670 N SNELLING

SITE PLAN APPROVED

OFFICE OF DSI
CITY OF ST. PAUL

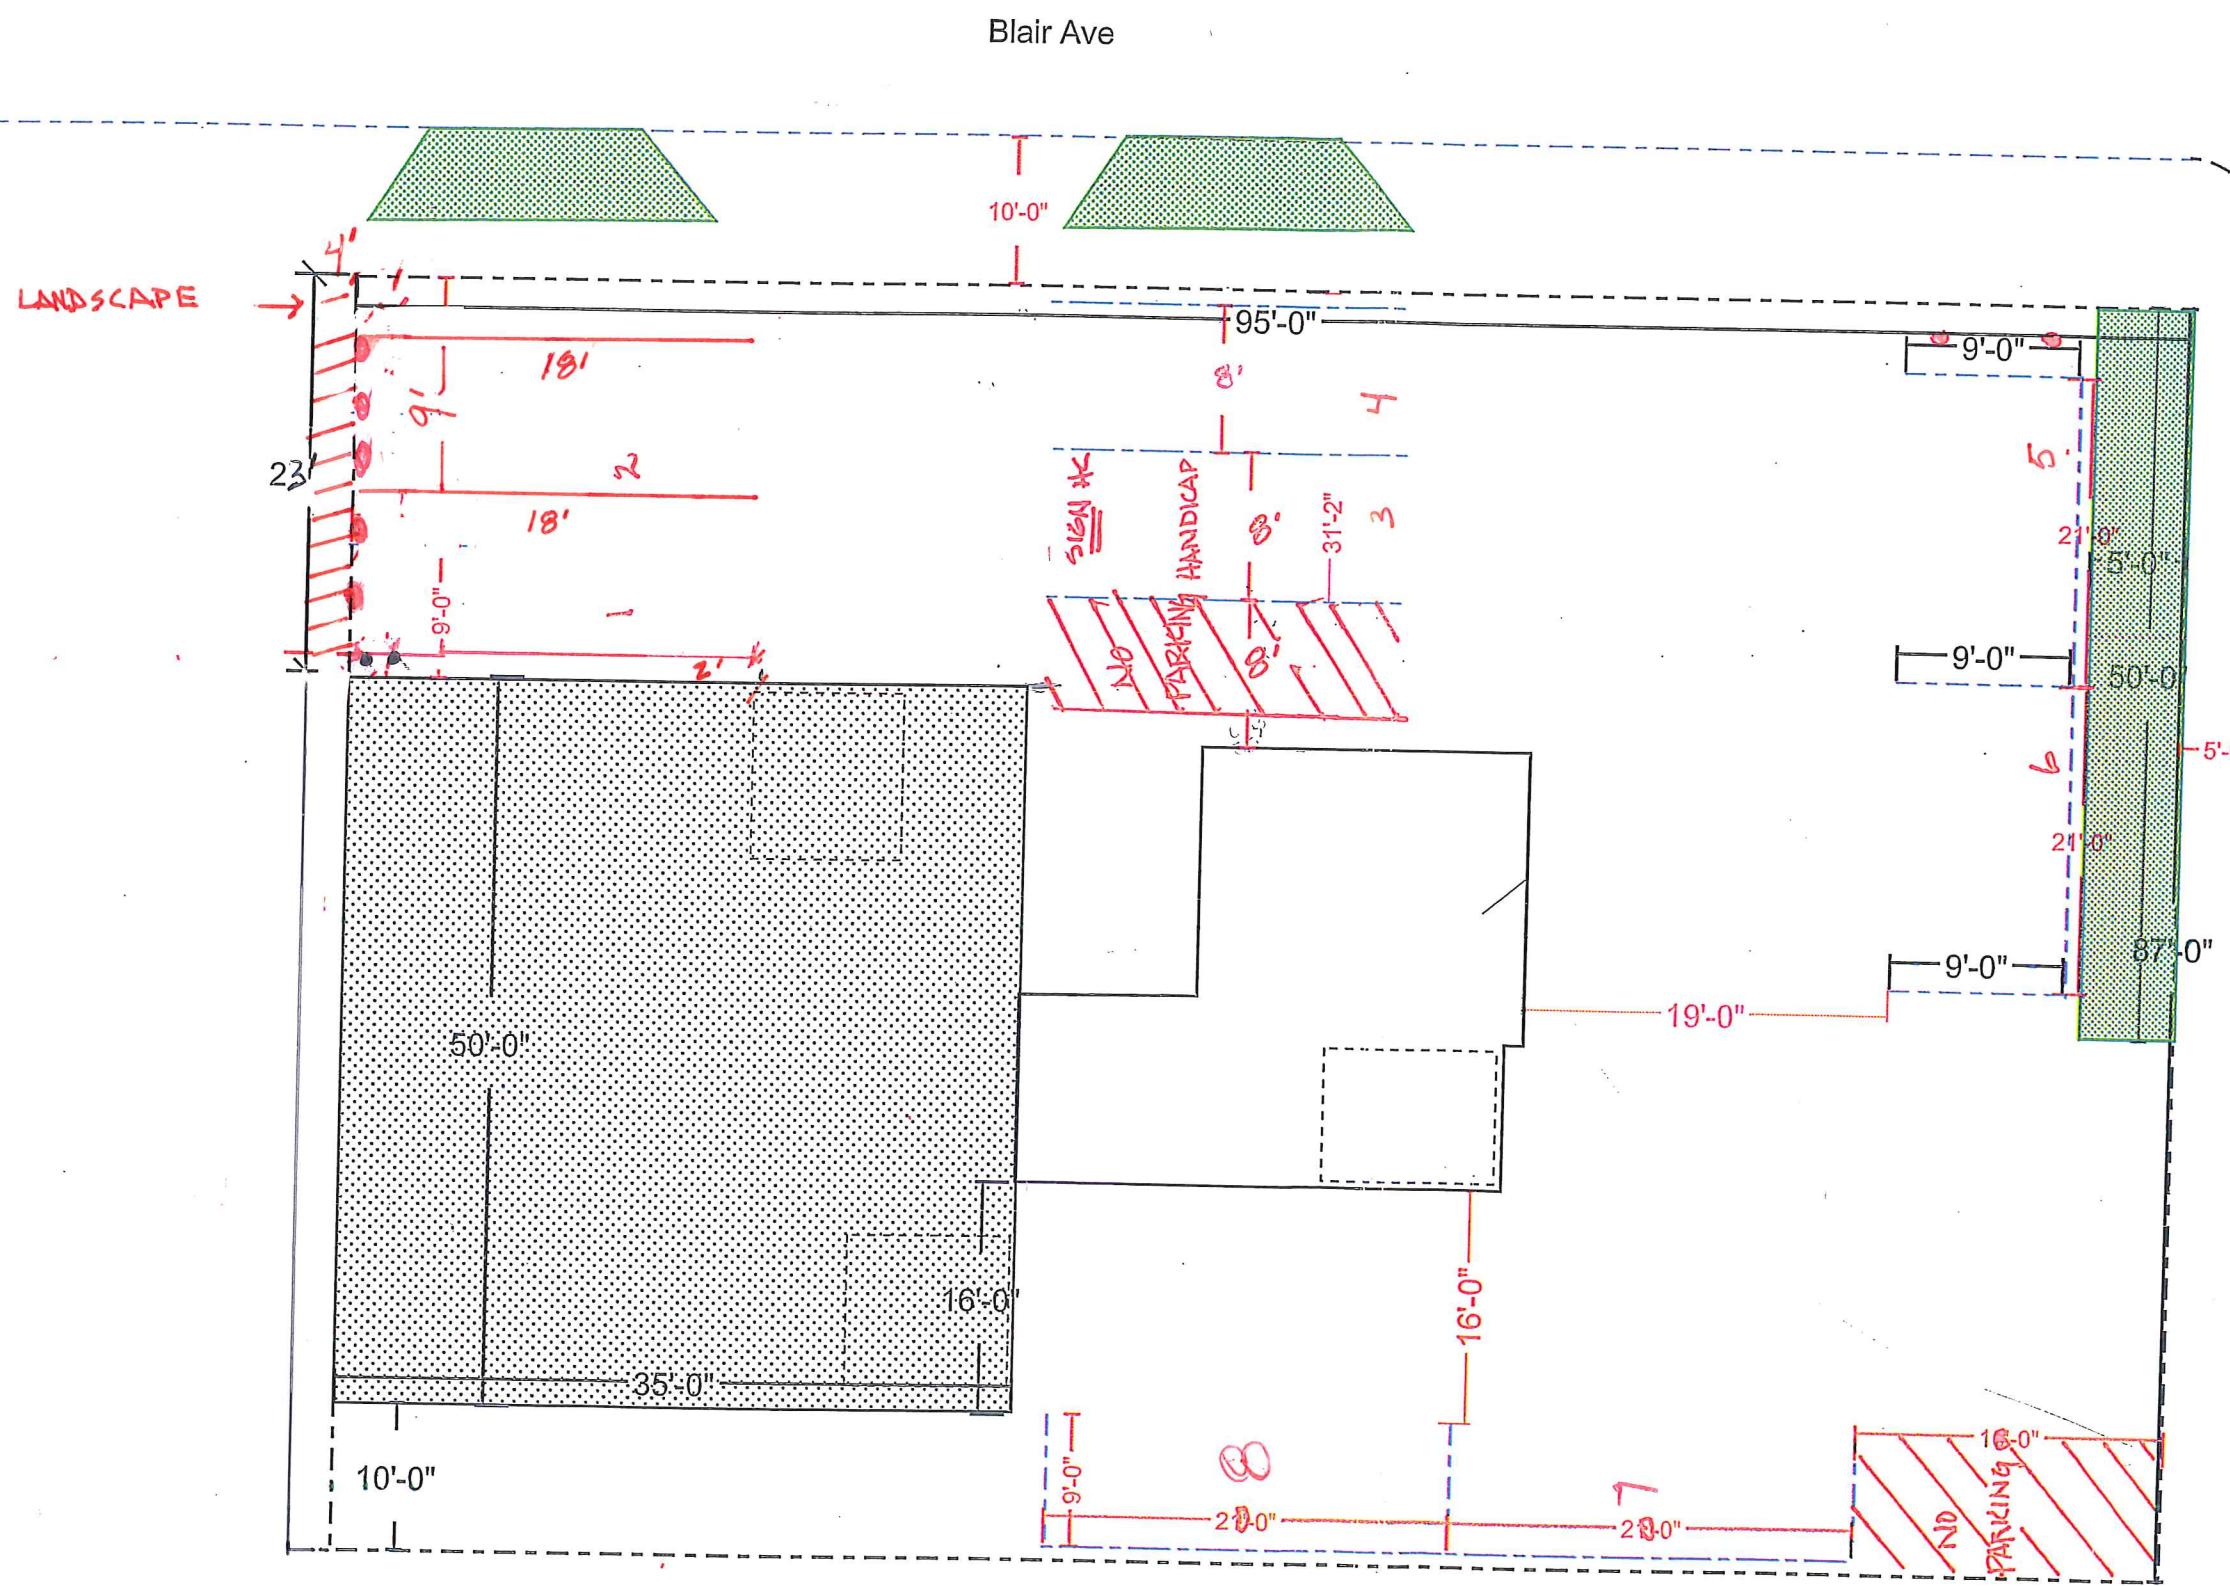
Approved per conditions:

- 1) Trash shall be contained within the building until pickup day.
- 2) ADA parking sign shall be installed on parking space number three (3).
- 3) Bollards shall be placed at parking spaces #1, 2, to maintain 4' setback off property line and #5 parking space to maintain vehicle within property line.
